The application of 4M change

Supplier: Zhe Jiang Rectron Electronic Co., Ltd

Date: 2018-10-26

Content (After) :

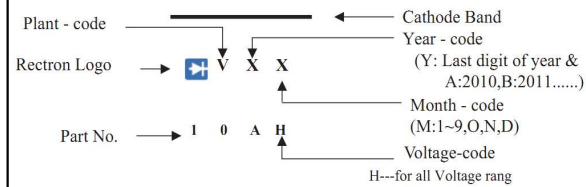
- 1) Device body marking change from "10A05", "10A1"***etc to "10AH".
- 2) Maximum Recurrent Peak Reverse Voltage (Vrrm) rating upgraded as below.
10A05 from 50V to 1000V 10A4 from 400V to 1000V 10A8 from 800V to 1000V
10A1 from 100V to 1000V 10A6 from 600V to 1000V 10A10 no change
10A2 from 200V to 1000V
- 3) No other fit, form or function changes
- 4) If the customer disagrees with the change, We will use Z to distinguish the material number.
- 5) P/O:P/N-packing code-Z;Type: P/N-packing code;Remark : -Z(For example: P/O:10A10-F-Z;Type:10A10-F)
